# PREDETERMINATION SETTLEMENT AGREEMENT

CP# 10-17-71046  
HUD# 07-18-7876-8

Subject Property

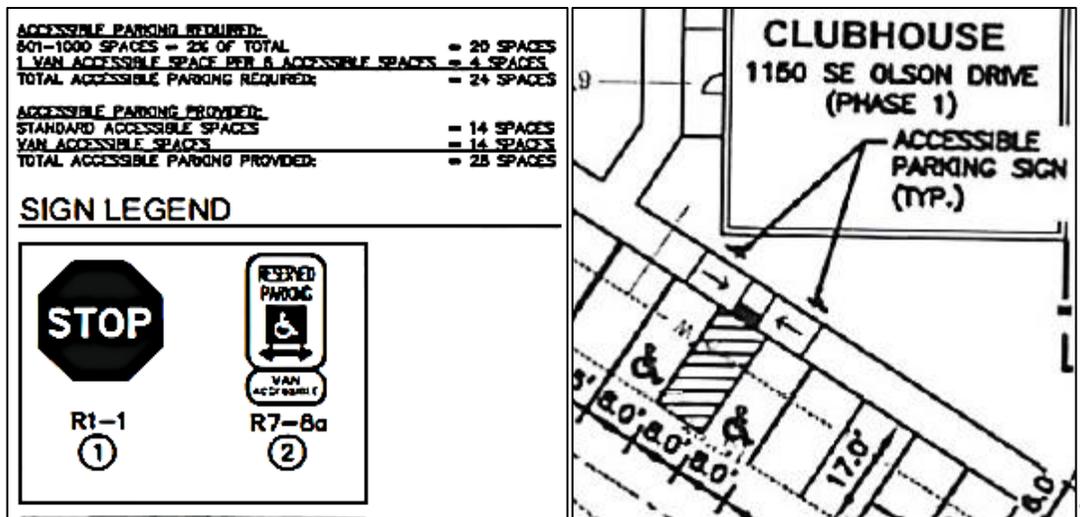
- 1) At both parking spaces reserved for persons with disabilities adjacent to Building 1150, the height to the bottom edge of the signage was measured at 55<sup>3</sup>/<sub>8</sub>” which is less than the minimum height of 60 inches required by ADAAG.<sup>4</sup> Although both parking spaces and access aisle were observed at Building 1150 – which meet the required ADA dimensions for Van-Accessible parking spaces and access aisles quoted above – neither of the two parking spaces had the required signage designating each as “Van-Accessible.”<sup>5</sup>

The plans submitted by Respondents include instructions and diagrams for the installation of signage designating spaces as reserved for persons with disabilities. The relevant instructions for the installation of these signs are shown at the top of the next page.

Based on these instructions, the signage designating parking spaces as reserved for persons with disabilities was designed to comply with the ADAAG requirement for signage designating at least one of these two parking spaces as “Van-Accessible.” However, as installed, neither one of these two parking spaces had the required “Van-Accessible” signage and both were too low. These deficiencies make the identification of parking spaces wide enough for vans and standard vehicles more challenging to identify.

Every effort has been made or is being made to bring the property into compliance as set forth in your Preliminary Findings. The coat rack and towel bars will be moved to the correct height. The animal waste stations will be moved to the correct locations. The handicap sign has been ordered and was to arrive last week and when received, it will be installed. The Post Office has been notified that the lower level respective boxes must not be in the top two rows and the boxes need to accordingly be lowered.
